**DESIGN/DEVELOPMENT REVIEW COMMISSION
DESIGN REVIEW DISTRICT
CITY CENTER/HISTORIC AGENDA
EVALUATION SHEET
Case # 5**

ADDRESS: 1213 Lady Street

NATURE OF REQUEST: Exterior changes and site improvements

1 ARCHITECTURAL SITE PLAN
 DDRC_1 1/16" = 1'-0" REFERENCED ON: A1.1

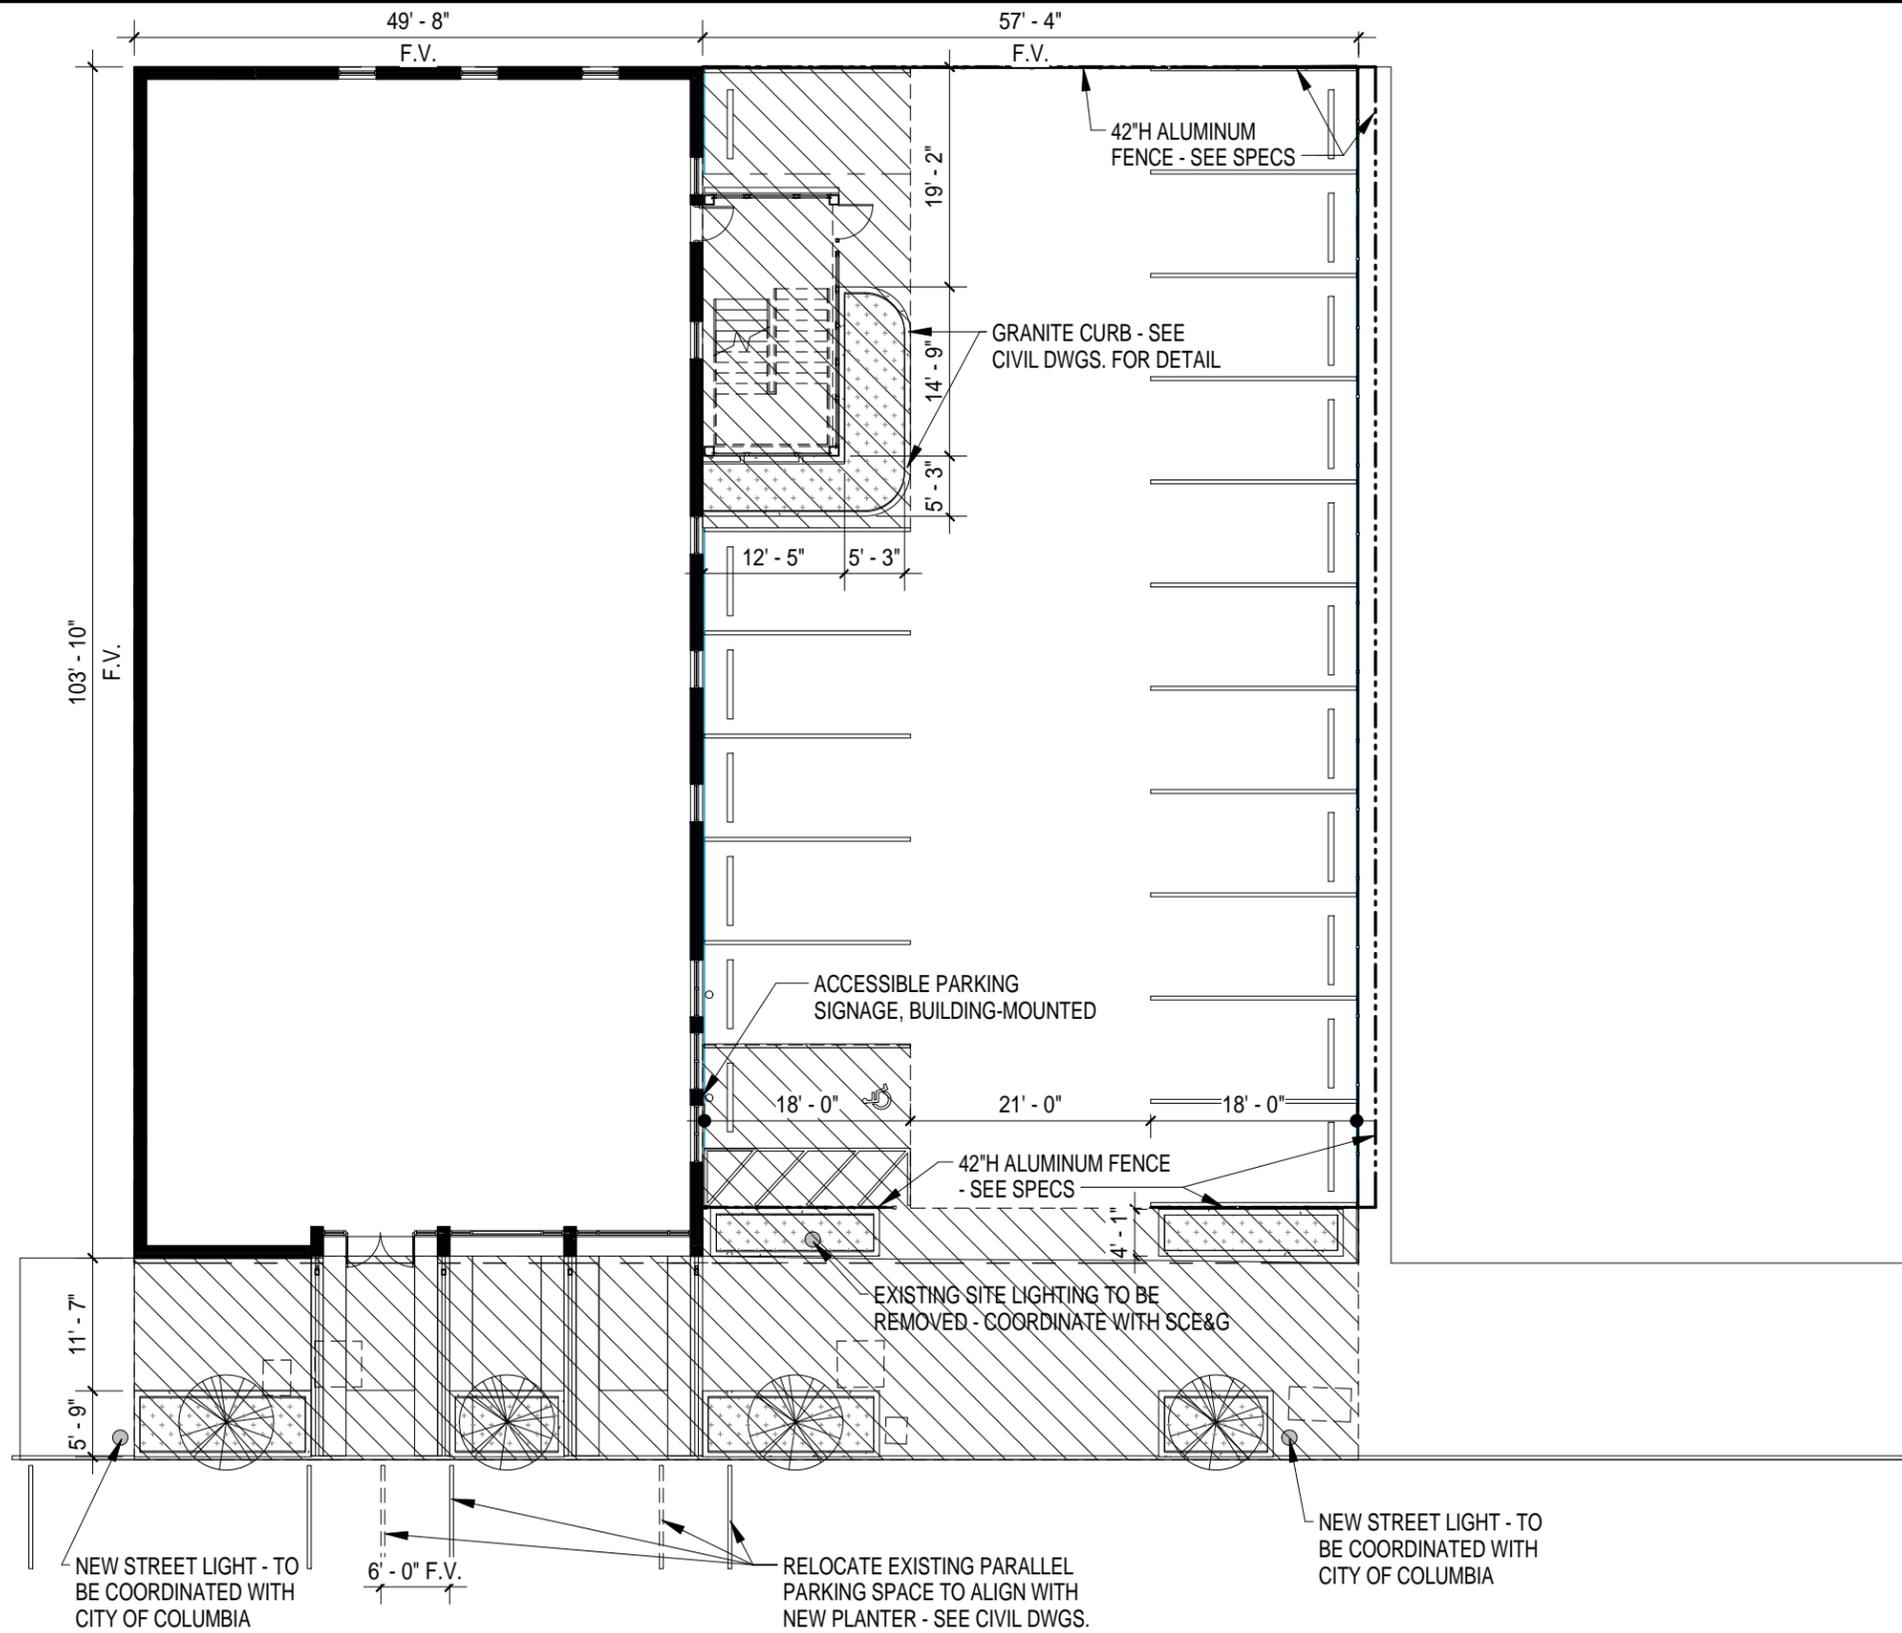
The applicant is providing one shade tree and a continuous evergreen hedge in locations between the sidewalk and the parking area.

One shade tree will be planted near the new staintower. Details regarding soil will be deferred to the Land Development Planner. Immediately under the trees, organic mulch should be provided.

1 SOUTH ELEVATION DDRC
 DDRC_2 1/8" = 1'-0" REFERENCED ON: A1.1

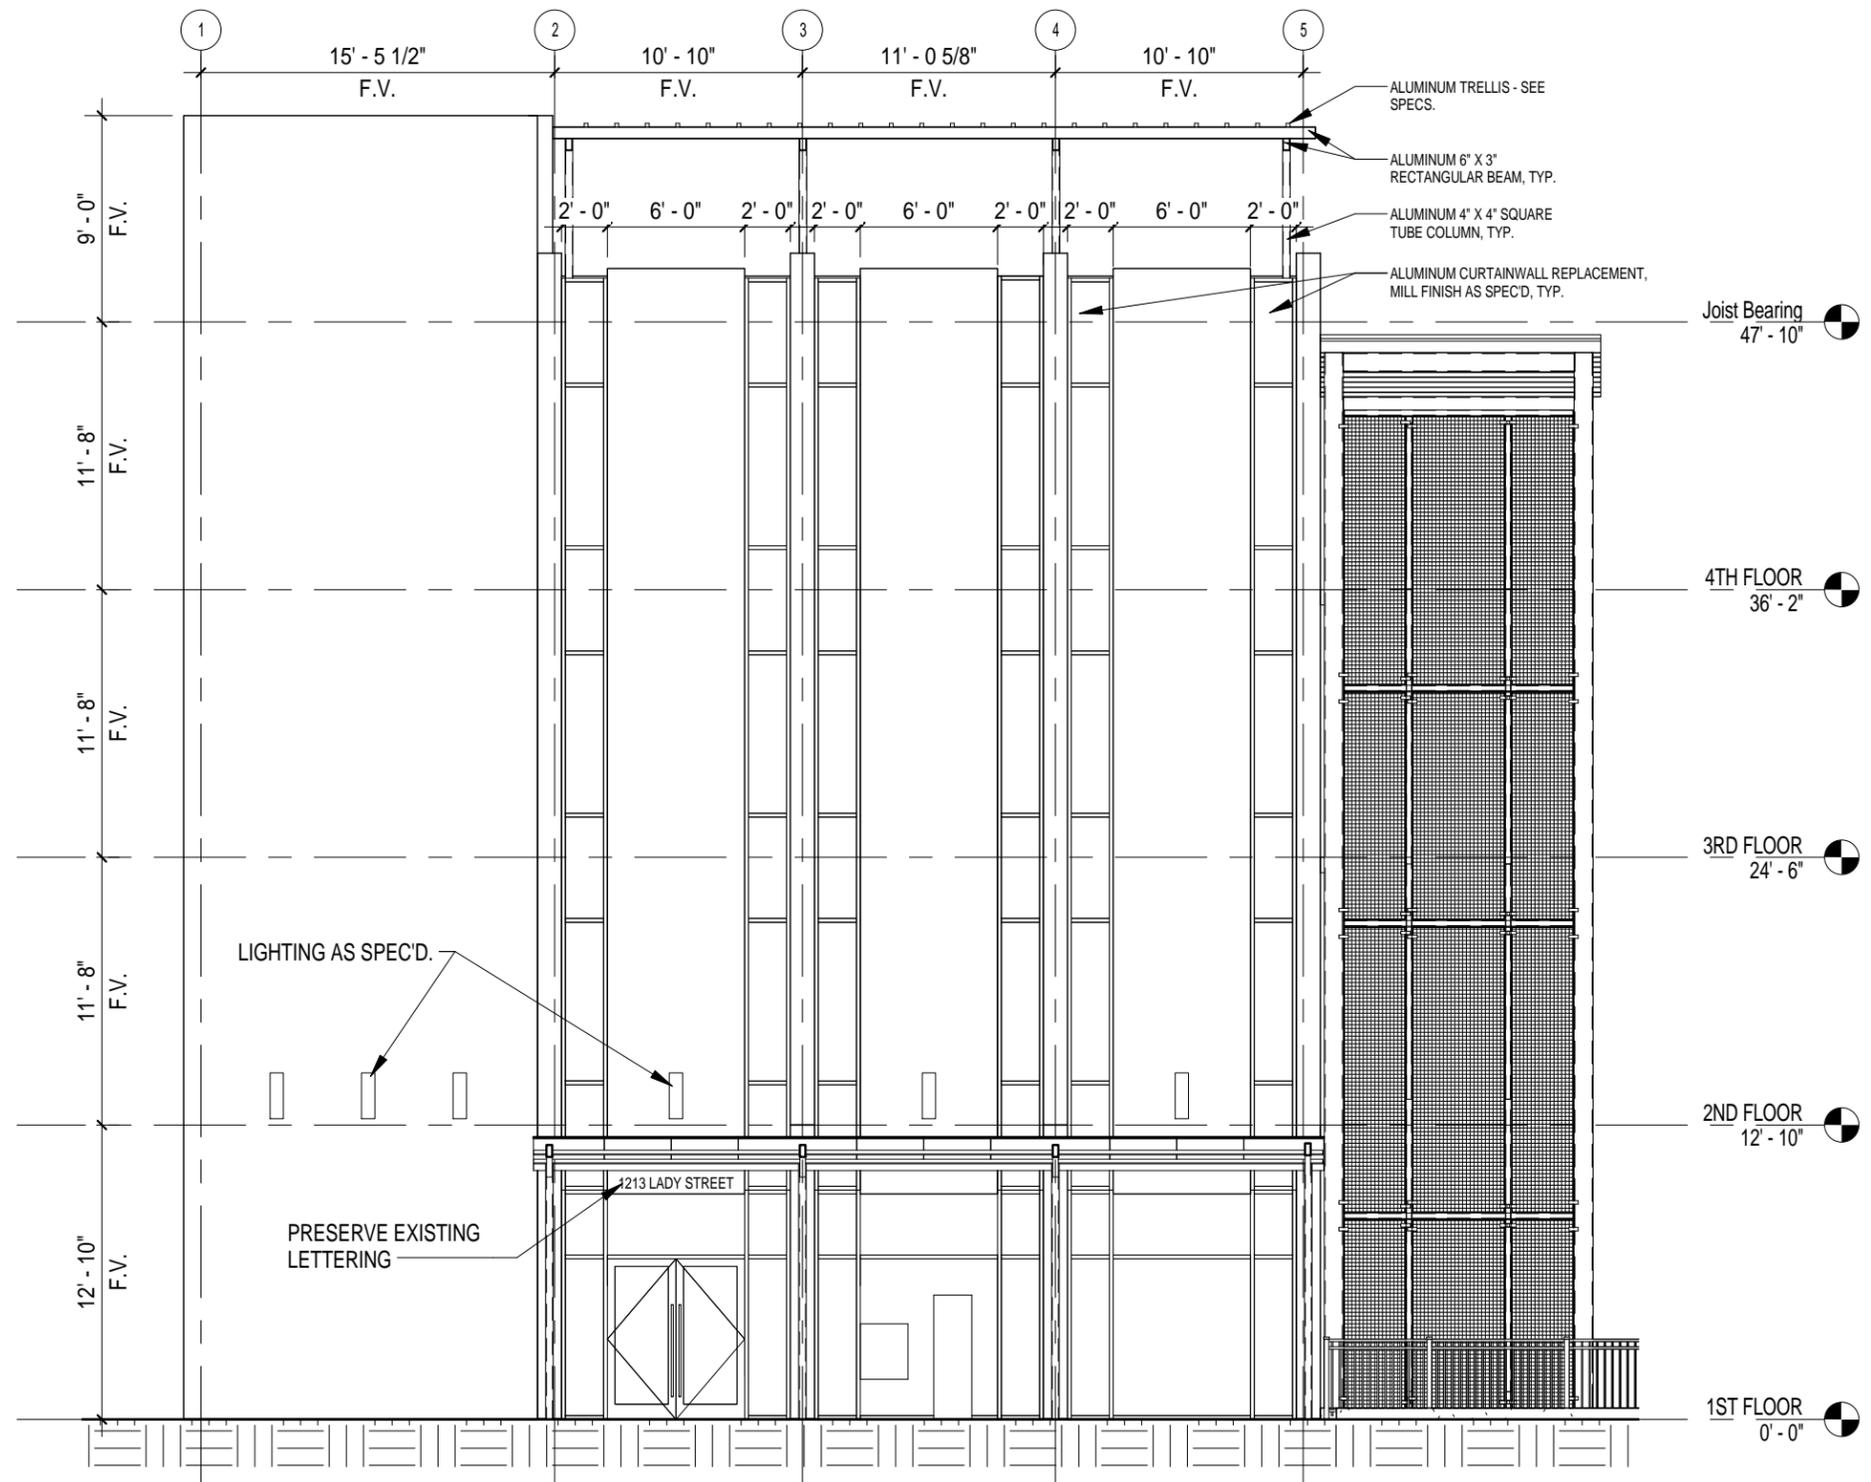
The original storefront is no longer extant; however, the applicant is proposing a new storefront that is somewhat based on the original design seen in historic photographs. The storefront will consist of 3-bays and will utilize an aluminum framed storefront system with insulated glass. The main entrance will be on the left side and will feature double doors. The center bay will have an integral drop box and ATM panel. The details of this bay will need to be reviewed by staff prior to installation. The right bay originally featured a pair of doors that matched those in the left bay as can be seen in early photographs of the building. The applicant's design for the right side bay is a departure from the original configuration as full glass instead of paired entry doors is proposed.

The curtainwall windows on the façade were previously replaced. The applicant is proposing to replace them with an aluminum curtainwall system with 1" insulated glass. The design and finish will be based on historical documentation and photographs.

A freestanding aluminum canopy is proposed as a design element above the storefront. The canopy will not be attached to the building in order to prevent damage to the historic materials on the façade. Although not a traditional canvas type feature, the modern interpretation of the canopy works well with the building's mid-century modern architecture.

An aluminum trellis will be installed on the roof of the building near the façade. This is merely a design element that could easily be removed in the future without damaging the building or affecting its architectural integrity.

1 EAST ELEVATION_DDRC
 DDRC_3 1/8" = 1'-0" REFERENCED ON: A1.1

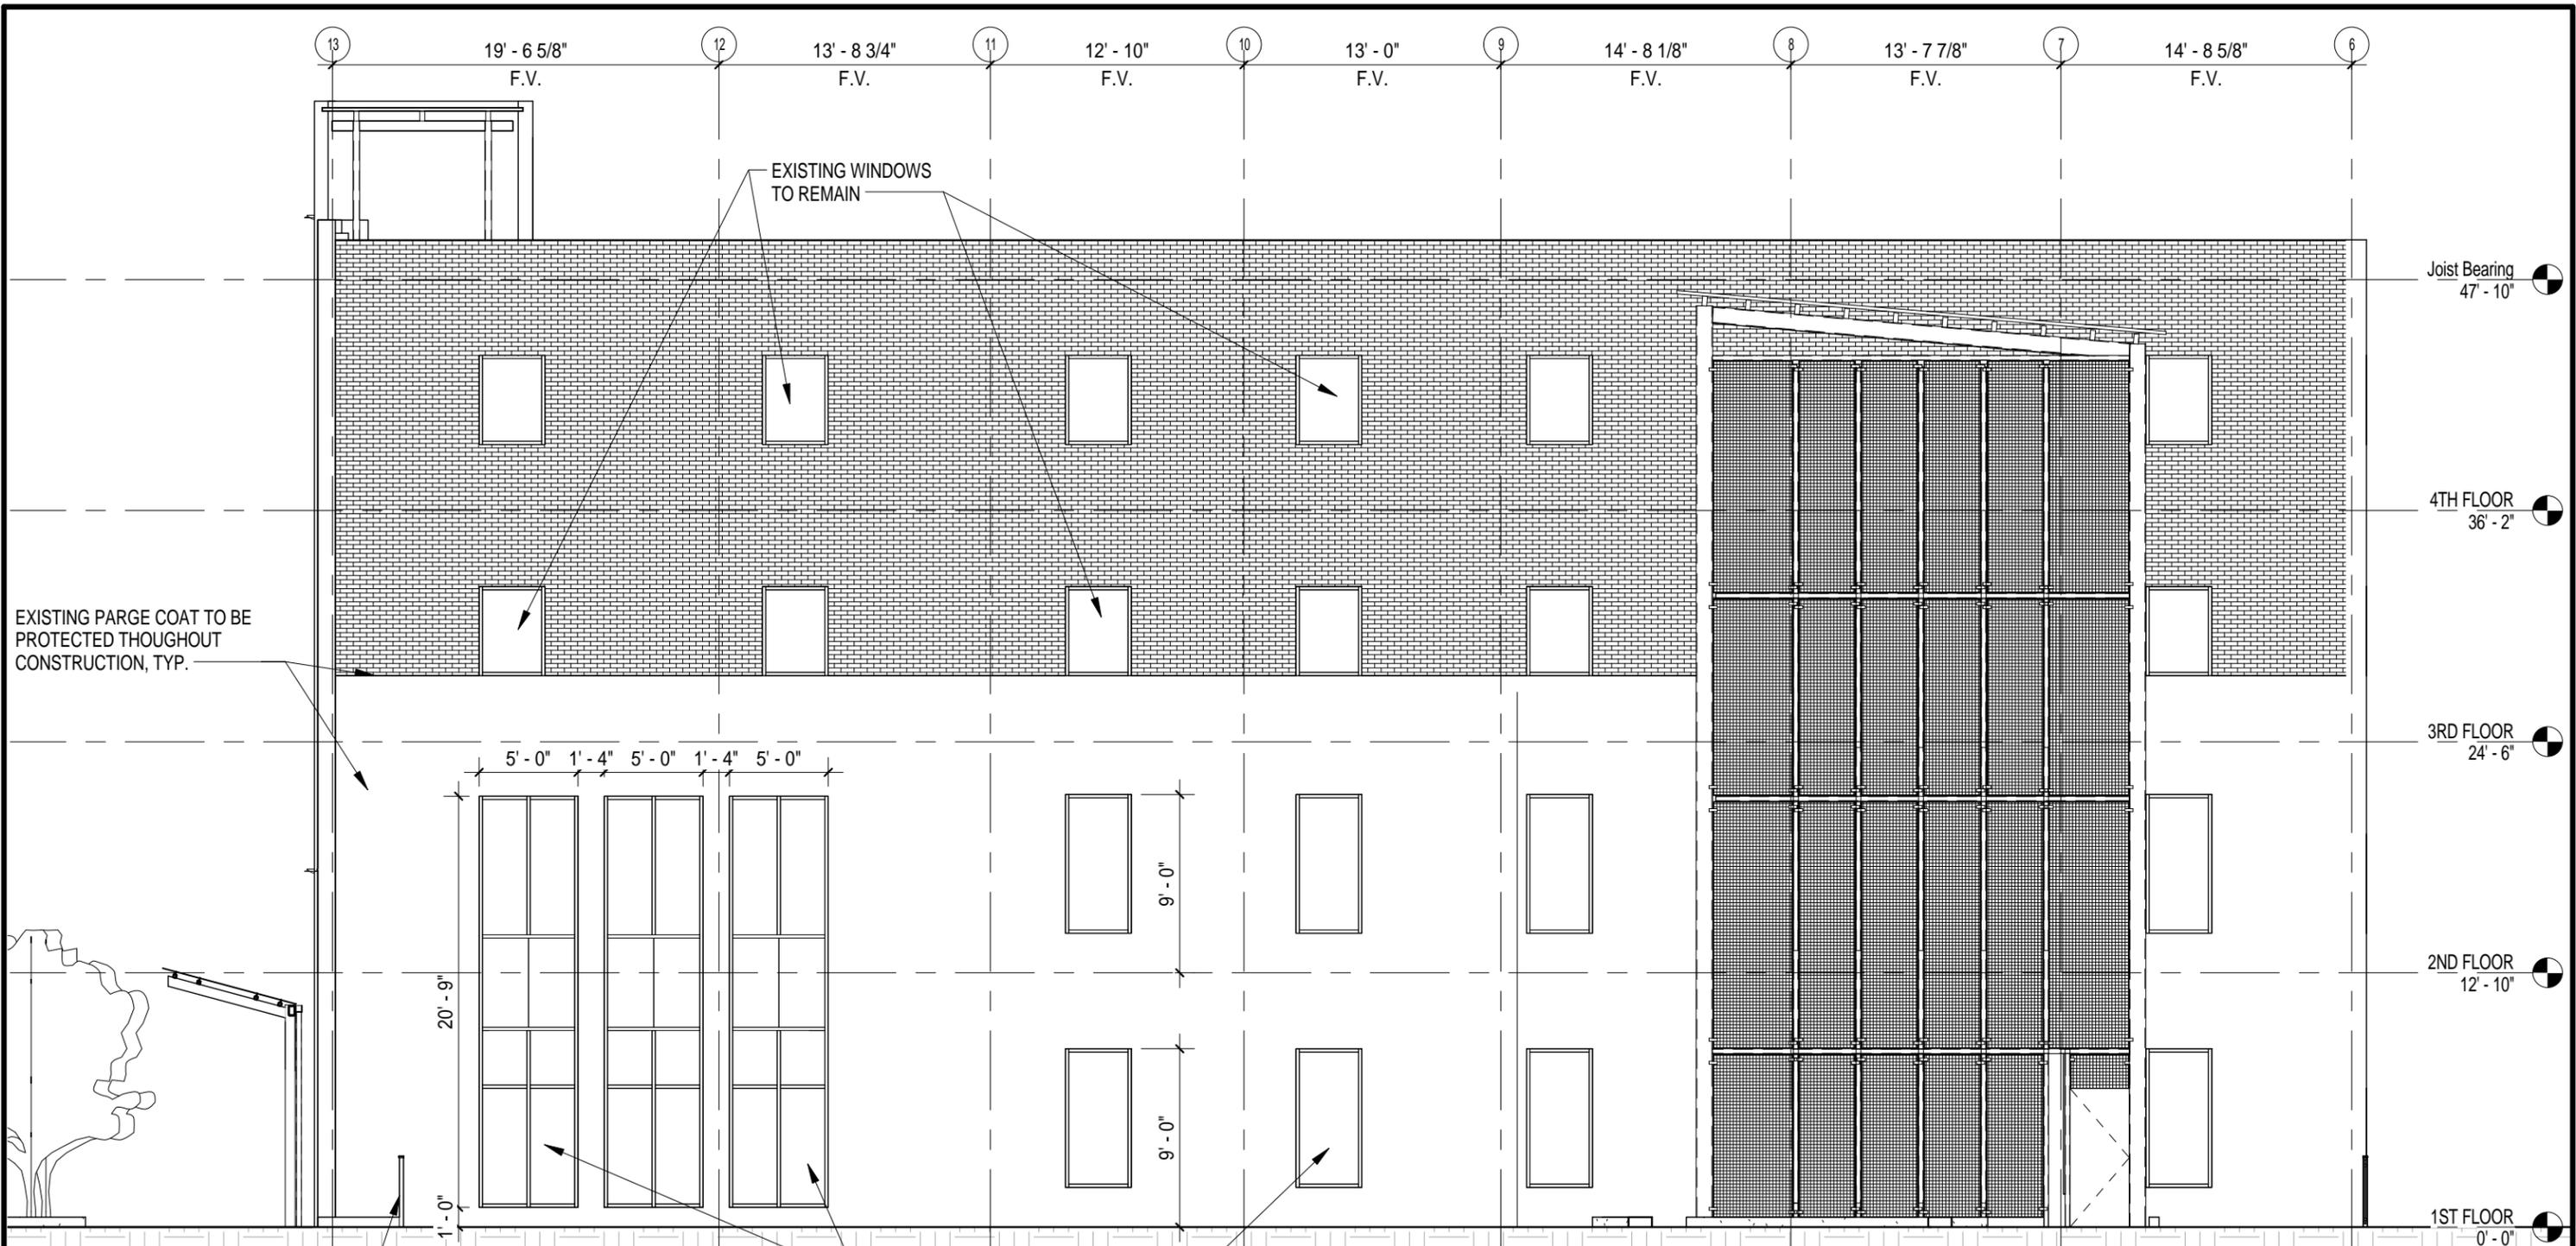
On the east side elevation the first two floors of the building originally had no openings, as they were adjacent to an existing building. The upper floors have what appear to be original windows. A two-story punched entry that has some design elements mimicking some of the façade's measurements and details is proposed for the east elevation. As this is not the main façade and there are no original openings in this location (since this wall was hidden a building that was once immediately adjacent to 1213 Lady St.), there is room for working out an entry at this location. Finally there is an exterior stairwell with a screen wall located at the back corner of the east elevation in the rendering, a design element that would not obscure important architectural detailing.

The existing upper windows on the right side will be retained and repaired. New openings will be made on the lower two floors of the right side of the building. This is currently a blank wall that was once blocked by an adjacent building that is no longer extant. The windows follow the original fenestration pattern but are taller than the existing windows. The additional height may help to differentiate the old from the new so that they are not interpreted as original features.

A wire mesh staintower will be placed on the rear of the building as shown on the attached elevations. This feature harmonizes with the building but is distinct in terms of design and materials. If removed in the future, the essential form and integrity of the building would remain.
